# Access Compliance Report

## Public Rights-of-Way

Intersection ID: 2710	Main Street: FAIRVISTA_DR	Cross Street: QUEENSBURY_CT	Location: NE
ADA ID: EAF3EFC1EAD7	Ramp Type: PerpDiag	Initial Pass/Fail: Pass	Overall Compliance: No
			Severity Score: 30.25

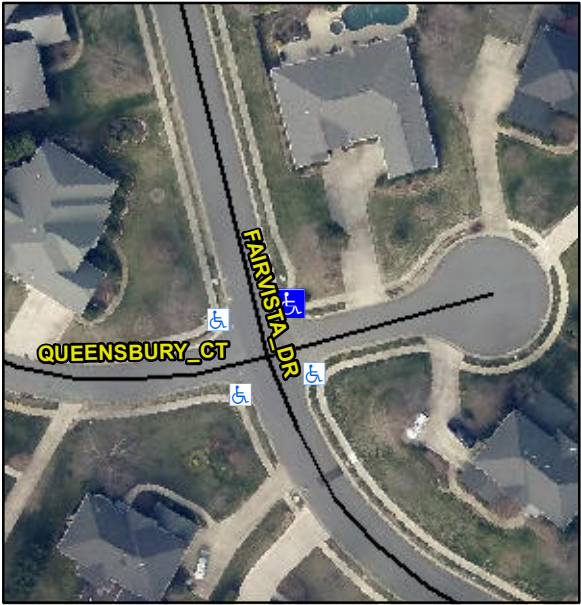
Codes/Mitigation Info/Possible Solution			Field Measurements/Component Compliance			
	Possible Solutions:		<b>Compliance</b>	<b>Description</b>	<b>Data</b>	
	Remove & Replace Curb Ramp With Two New Directional Ramps or Equivalent. Remove & Replace Gutter.		<b>Compliance</b>	<b>Description</b>	<b>Data</b>	
			N/A	Ramp Length (in)	74.0	No
			Yes	Ramp Width (in)	51.0	No
			N/A	Flare Type LT	Sloped	N/A
			N/A	Flare Slope LT (%)	2.7	Yes
			N/A	Flare Traversable LT?	Yes	N/A
			No	Landing Length (in)	N/A	No
			No	Landing Width (in)	N/A	No
			No	Landing Slope (%)	N/A	N/A
			No	Landing X Slope (%)	N/A	N/A
			N/A	Landing Curb? (Y/N)	No	N/A
			N/A	Shared Landing?	No	
			Yes	Gutter Ponding?	No	Yes
			No	Gutter Lip Ht (in)	0.5	No
			N/A	Painted X Walk1?	No	N/A
				X Walk 1 Direction	To W	
			N/A	X Walk 1 Width (in)	N/A	N/A
				X Walk 1 Slope (%)	6.2	
				X Walk 1 X Slope (%)	4.9	
			N/A	Ramp inside XWalk1?	N/A	N/A
				Road Slope (%)	1.9	N/A

**Not Found, R304.2.2, R304.5.3, R304.2.1, R304.2.2-Perp, R304.3.2-Para, R305, R302.7.2**

**Remove & Replace Curb Ramp With Two New Directional Ramps or Equivalent. Remove & Replace Gutter.**
